IN THE CLAIMS:

REMARKS

FIG-1

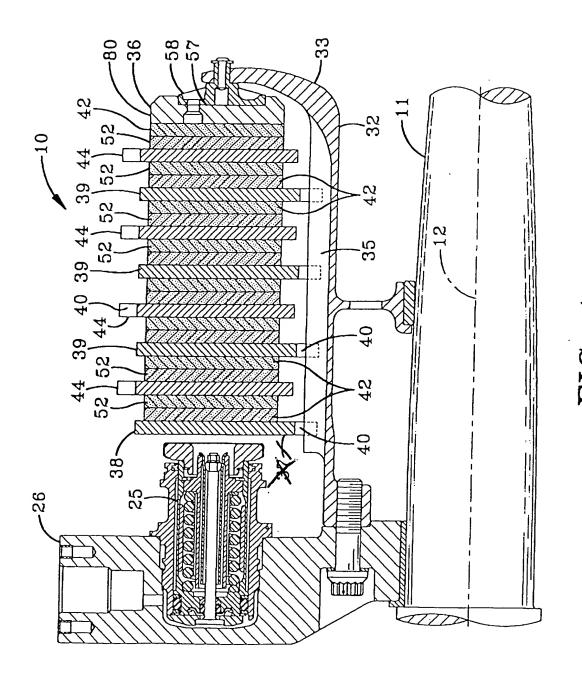
The drawings have been objected to as failing to comply with 37 CFR § 1.84(p)(5) because they include elements 37 and 52 shown in FIG. 1. Corrected FIG. 1 is included to delete element 37. Element 52 is described clearly on page 11 of the specification as the rotor lining in FIG. 1. No new matter is added to the application.

The drawings were objected to under 37 CFR § 1.83(a). The Examiner noted that the drawings must show every feature of the invention specified in the claims. The Applicants respectfully submit that the drawings do show the different thicknesses of the wear portions of the brakes and respectfully request further clarification from the Examiner or withdrawal of this objection.

Page 11, line 22, after "friction lining" insert -- 42 --;

line 23, after "rotor lining" insert -- 52 --.
